C/FM SCFM	P 1	L 25	# 1		C/ 116	SC 116.1.4	P 28	L 8	# 4	
Hajduczenia, Marek	Charter	Communications			Brown, Matt		Huawei			
Comment Type E	Comment Status	0		bucket	Comment T	/pe ER	Comment Status A			
SuggestedRemedy	' is no lomnger correct ·		2 release		400GBA	SE-Z optical	n the defined margins. It wo PHYs. Note that 400GBASE ASE-Z as defined in 1.4.144	-ZR is part of the		yer
Change all dated refer	ences to 802.3 from 20	2x to 2022			SuggestedR	emedv				
Proposed Response PROPOSED ACCEPT					Change with app type and	title of Table propriate edito d clause corre	116-5 to "PHY type and clau rial instruction and change fo lation (400GBASE-Z optical)	rmating. Insert ne " and include the	w Table 116-x "PHY row for 400GBASE-2	(
C/ 120A SC 120A.6	P 103	B L 8	# 2		•	ded in Table ?	116-5 in D2.0 with only the n	ecessary columns		
Hajduczenia, Marek	Charter	Communications			Response		Response Status C

SORT ORDER: Comment ID

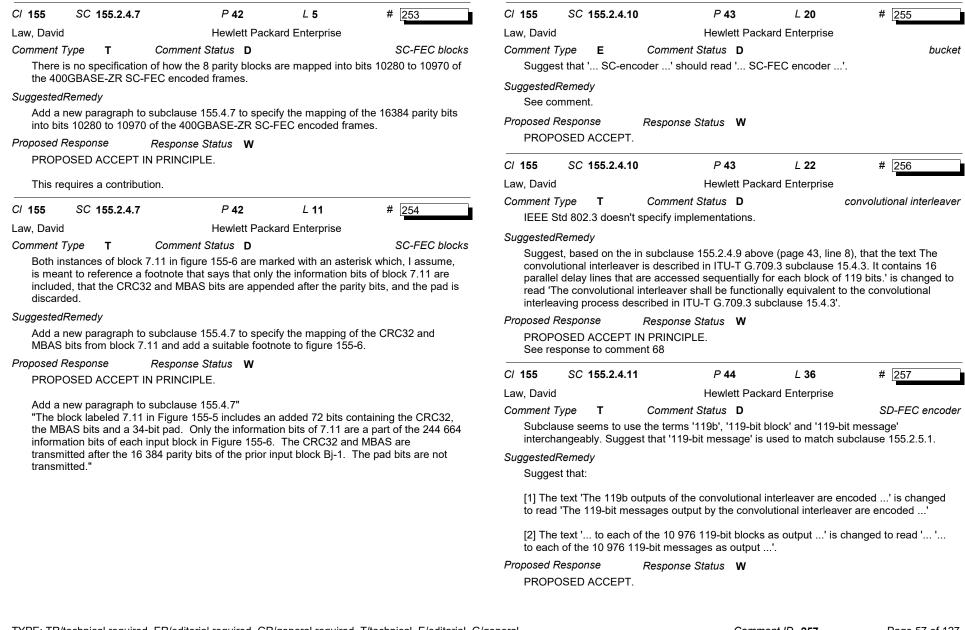
contents of the sub-frame 0 between P4 and P115, and sub-frame 1 and 48 between nd P115, are not defined in Figure 155-12.

ub-frame 0, the number of symbols shown in Figure 155-12 after P0, P1, P2, P3 and is 31. A sub-frame is 3712 symbols long, and there are 116 PS symbols, and since /32 = 116 it seems reasonable to assume that there are 31 symbols after every PS ol for sub-frame 0, but this needs to be specified.

ub-frame 1, the number of symbols shown in Figure 155-12 after P0 is 31, after P1 is owever, after P115 it is 32. Similarly, for sub-frame 48, the number of symbols shown ure 155-12 after P0 is 42, after P1 is 31, and after P115 it is 32. It is therefore difficult ake an assumption about the number of symbols after each PS between P2 and so this needs to be specified.

ify the contents of the sub-frame 0 between P4 and P115, and sub-frame 1 and 48 een P2 and P115.

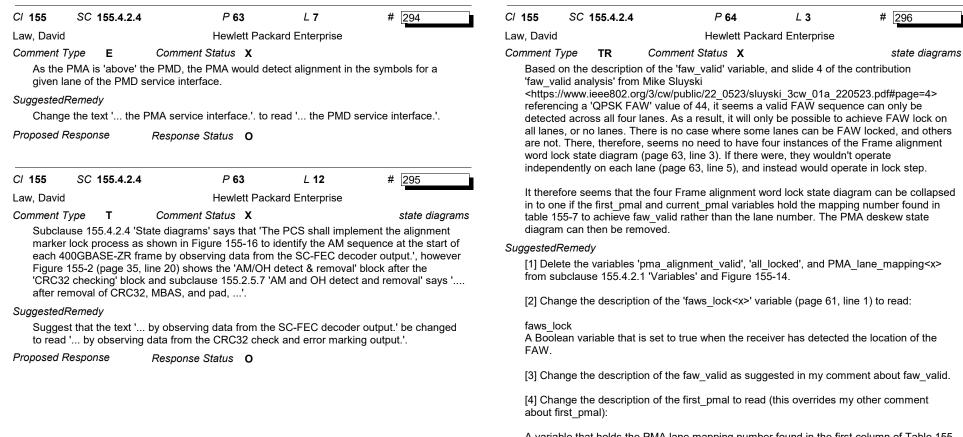
Subclause 155.4.2.3 'Counters' defines the 'cw bad count' counter, however this counter is not reference anywhere else in the draft.

Delete the 'cw bad count' counter definition.

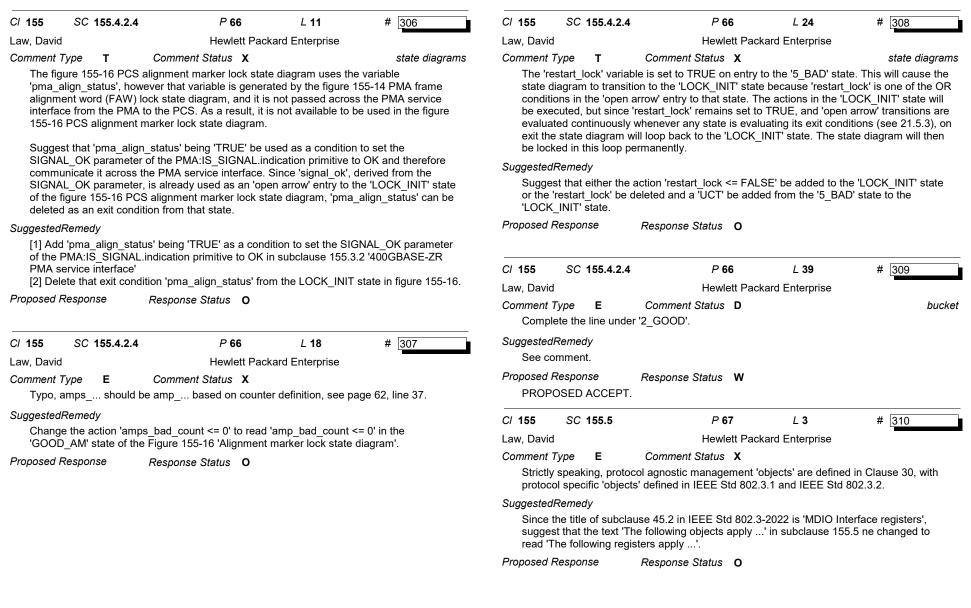
Change the text 'slip done <= FALSE' in the GET BLOCK state in Figure 155-14 to read 'faw slip done <= FALSE'.
